GE Hitachi Nuclear Energy

MFN 08-199, Supplement 2

Subject: **Response to Portion of NRC Request for Additional Information Letter No. 246 Related to ESBWR Design Certification Application - RAI Numbers 19.1-167 S01 and 19.1-169 S02**

RAI Numbers 19.1-167 S01 and 19.1-169 S02

Hurricane Fragility Curve Parameters¹

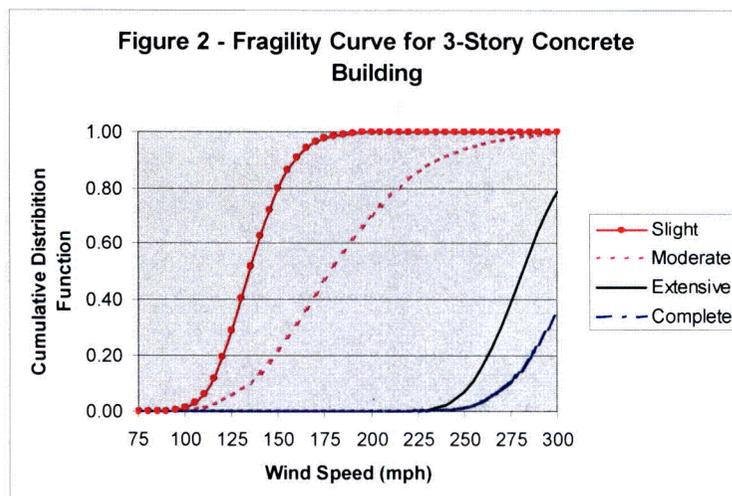
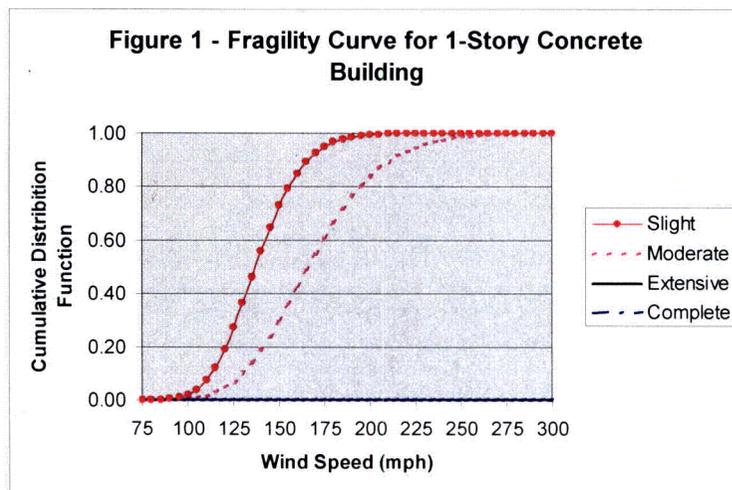
In 19.1-169 SO1, the staff asked GEH to provide the engineering basis for the estimated conditional failure probability of a Seismic Category 1 structure subjected to a Category 4 or 5 hurricane. In particular, GEH was to justify the conditional probability of no significant damage to Seismic Category 1 structures from such winds. GEH provided a response in August 1, 2008, that was deterministic and not probabilistic in nature. It discussed that Seismic Category 1 structures are to be built to meet seismic design loads that considerably exceed the loads associated with high wind events. It did not provide a numerical or engineering basis for the seven orders of magnitude reduction in risk assigned by GEH to the robustness of the Seismic Category 1 structures compared to high winds events, nor did it discuss uncertainties or the effects of design or construction errors. The staff finds this response unacceptable.

The staff would find is acceptable for GEH either to (1) provide a probabilistic defense for its use of seven orders of magnitude reduction in risk that provides an engineering basis for the reduction that links the strengths of the design to specific numerical analyses (e.g. fragility curves) that address conditional probabilities of failure, or (2) provide qualitative arguments as to why high winds do not constitute outliers in risk, qualitative arguments why high winds do not challenge the Safety Goals, a discussion of why the risk from high winds events is lower than for operating plant designs, and a list of safety insights that are important for the as-built, as-operated plant to follow to assure that the assumptions in the high winds risk analysis are valid and remain valid during the lifetime of the plant. Use of Option 2 could satisfy the requirements of 10 CFR 52 that an applicant address Safety Goals, risk outliers, and reduction in expected risk compared to existing plant designs. However, a qualitative analysis does not constitute a probabilistic risk assessment.

Assumptions used in conducting the ESBWR high wind risk analysis state that no significant damage of the seismic category I (SC I) structures will occur from hurricane Category 4 or 5 winds. This assumption is supported in part by the design basis of SC I ESBWR structures. In addition, fragility curves (provided below) were developed for one- and three-story concrete buildings based on gust wind speeds over the range of hurricane wind speeds of 75 to 300 miles per hour (mph). The one-story fragility curve is characteristic of the ESBWR control building (CB), fuel building (FB) and fire service water complex (FWSC); the three-story fragility curve is characteristic of the ESBWR reactor building (RB). The probability of extensive or complete damage to a one-story concrete building is essentially zero over the range of hurricane wind speeds. Similarly, a probability of extensive or complete damage to three-story concrete buildings is essentially zero up to a hurricane gust speed of about 225 mph. This further supports the ESBWR high wind risk analysis assumption that no significant damage of the SC I structures will occur from hurricane Category 4 or 5 winds.

Furthermore, the frequency of complete failure of the RB and the frequency of occurrence of a major hurricane (Category 3, 4 or 5) combined to result in an overall failure rate of less than $1E-12$ per year of the ESBWR RB and is considered to be statistically insignificant.
